# Pedestrian Lighting in Chinatown International District

# Seattle Department of Transportation (SDOT) Review

*Example of lighting fixture and pole type.*

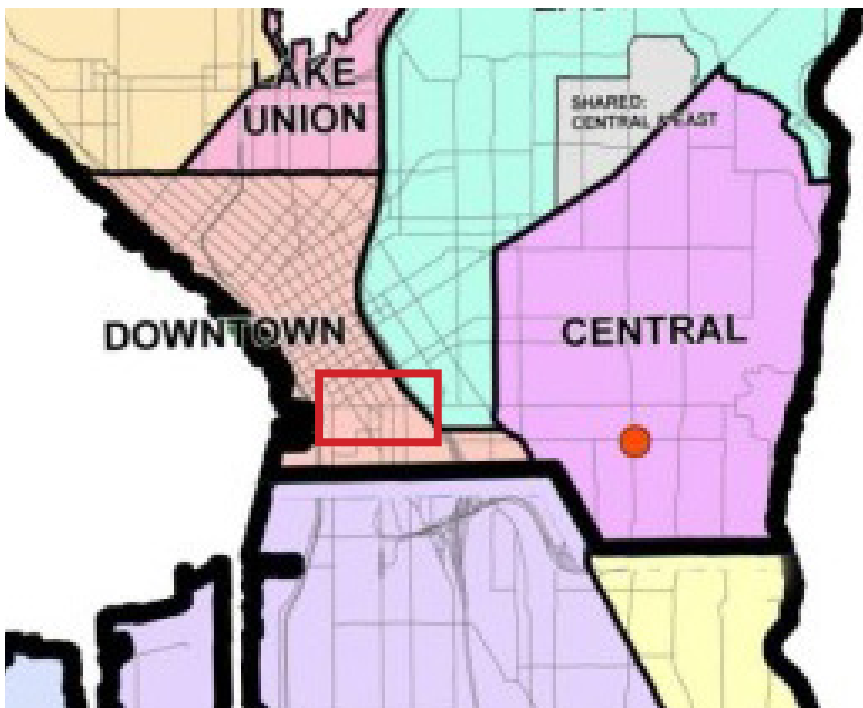
Lighting improvements could include simply installing a pedestrian lighting fixture to an existing pole, or it could involve installing a new pedestrian lighting fixture with pole and foundation including all associated elements such as trenching, conduit, and conductors. This could also include roadway/sidewalk restoration and any other improvements, such as ADA ramps, triggered by the trenching required to provide power to the new poles. Design for this project would incorporate Seattle City Light's new LED pedestrian light.

The Chinatown International District is part of a historic district. This project will require International Special Review District Board approval during the design process to ensure that any new lighting maintains consistency and compatibility with other fixtures in the District.

- Although not determined, light pole locations will need to account for existing areaway locations.
- Conduit locations may need to be routed within areaways or placed under the roadway surface.
